PRE-BID CLARIFICATIONS NO. 3 DATED 30.09.2025 TO PRE-BID QUERIES ON STIPULATIONS OF BID DOCUMENT AGAINST NIB NO. 483 DATED 27-05-2025 FOR "PACKAGE-III: CIVIL WORKS OF POWER INTAKE, HEAD RACE TUNNEL, SURGE SHAFT, VALVE CHAMBER, PRESSURE SHAFTS & PENSTOCK, UNDERGROUND POWERHOUSE COMPLEX (COMPRISING OF POWERHOUSE CAVERN, TRANSFORMER - GIS CAVERN, COLLECTION CHAMBER, MAIN ACCESS TUNNEL (MAT), CABLE ACCESS TUNNEL (CAT)) UNIT TAIL RACE TUNNELS, MAIN TAIL RACE TUNNEL, POTHEAD YARD AND VARIOUS CONSTRUCTION ADITS PERTAINING TO TATO-II HYDRO ELECTRIC PROJECT (700 MW), ARUNACHAL PRADESH"

(THIS PRE-BID CLARIFICATIONS SHALL SUPERSEDE THE CORRESPONDING STIPULATIONS OF THE BID DOCUMENT, WHEREVER THESE ARE AT VARIANCE.)

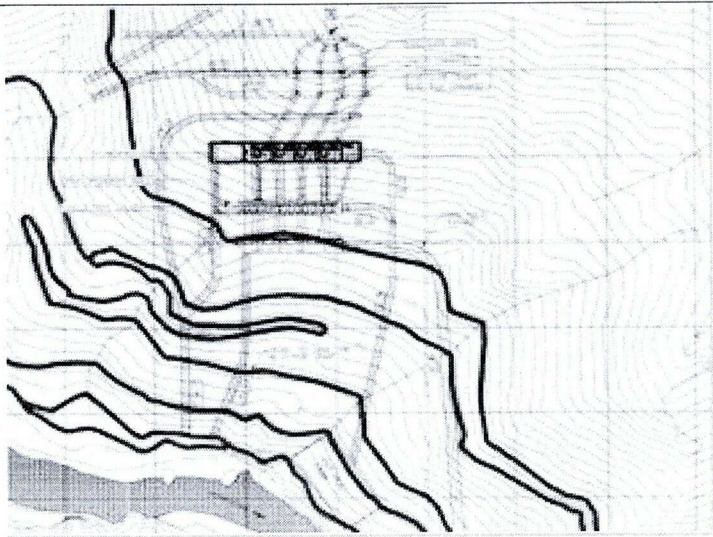
58	Part-6: Tender Drawings NEEPCO/TATO-II/PKGIII/010		As per layout plan, Adit 5 (6.5m x 7m) D shape is shown as Adit to bottom valve chamber. The invert level of adit in valve is EL 976.1m. The crown level of valve house (as per drawing number NEEPCO/TATO II/PKG-III/015 Sheet 1 of 1) is 1002.3m . The invert level of valve house chamber is El 976.1m.The total depth of excavation from valve house crown	Details shall be shown in the construction drawings.

DETAILS OF ADITS		ADIT NO.	REMARKS	M-1	MAT 8.0m DIA MODIFIED D-SHAPED	A-1	ADIT TO PRESSURE SHAFT BOTTOM	A-2	VENTILATION CUM CABLE TUNNEL TO P.H.	A-3	CABLE TUNNEL MODIFIED TO T.H.	A-4	T.R.T. (11.0m WIDE) DIA MODIFIED D-SHAPED	A-5	ADIT FOR BOTTOM VALVE CHAMBER	A-6	ADIT FOR PRESSURE SHAFT ERECTION CHAMBER	A-7	ADIT FOR S.S. TOP	A-8	ADIT FOR H.R.T. NEAR SURGE SHAFT	A-9	ADIT FOR COLLECTION GALLERY	to the invert location is estimated as 26.2m The construction of valve house involves excavation of central gullet and side slashing followed by benching up to final level i.e. EL 976.1m. Considering the valve house size and scope /excavation height, bidder presume that the additional adit to valve house cavern (extension from Adit 6) shall be permitted by Client during construction stage. Please confirm.	
DETAILS OF ADITS																												
ADIT NO.	REMARKS																											
M-1	MAT 8.0m DIA MODIFIED D-SHAPED																											
A-1	ADIT TO PRESSURE SHAFT BOTTOM																											
A-2	VENTILATION CUM CABLE TUNNEL TO P.H.																											
A-3	CABLE TUNNEL MODIFIED TO T.H.																											
A-4	T.R.T. (11.0m WIDE) DIA MODIFIED D-SHAPED																											
A-5	ADIT FOR BOTTOM VALVE CHAMBER																											
A-6	ADIT FOR PRESSURE SHAFT ERECTION CHAMBER																											
A-7	ADIT FOR S.S. TOP																											
A-8	ADIT FOR H.R.T. NEAR SURGE SHAFT																											
A-9	ADIT FOR COLLECTION GALLERY																											
59	Part-6: Tender Drawings NEEPCO/TATO-II/PKGIII/010	Layout Plan Showing Adits and Power House Adit 3 – Cable cum Ventilation Tunnel	As per layout plan, Adit 3 (Cable cum ventilation tunnel) to Transformer hall is shown, starting from pothead yard location & subsequently up to Powerhouse. The access road alignment is also shown on d/s side & u/s side of proposed pothead yard. Kindly confirm, if the access road alignment & location of Adit 3 portal are at same elevation. Secondly, tentative length of Adit 3 to transformer hall is estimated as 350	One of the two roads shown at the upstream and downstream side of Pothead yard will cater as the approach road to the Adit -3 portal. The alignment of roads shown in the drawings are tentative and actual alignment shall be decided during construction. As shown in the drawing invert of Adit-3 portal is at EL.845m.
